RULE NO.: R161-15.11

NOTICE OF RULE ADOPTION

R161-15.11: Revisions and additions to the Drainage Criteria Manual Section 1.2, *City of Austin Drainage Policy*; Section 8.5, *Detention Basin Maintenance and Equipment Access Requirements*; and Appendix D, *Figures and Diagrams* as follows:

Fig. 5-1

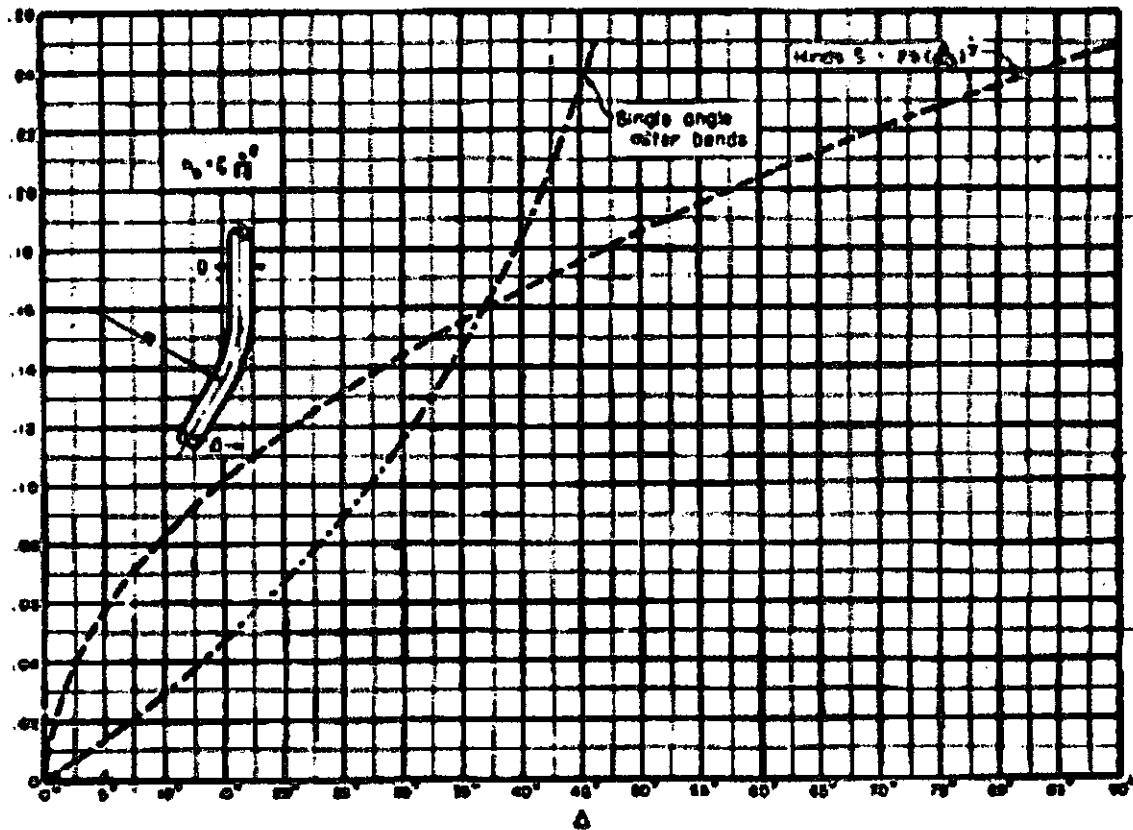
- Figures 5-1 and 5-2 have been added to help determine the headloss coefficients as per Table 5-3
 - Figure 5-1 “Headloss Coefficient for Cases 2 and 7”
 - Figure 5-2 “Headloss Coefficient for Case 5”

Headloss Coefficient for Cases 2 and 7
 Source: Urban Storm Drainage Criteria Manual
 Volume 1
 Urban Drainage and Flood Control District
 Denver, Colorado
 June 2001, Revised April 2008
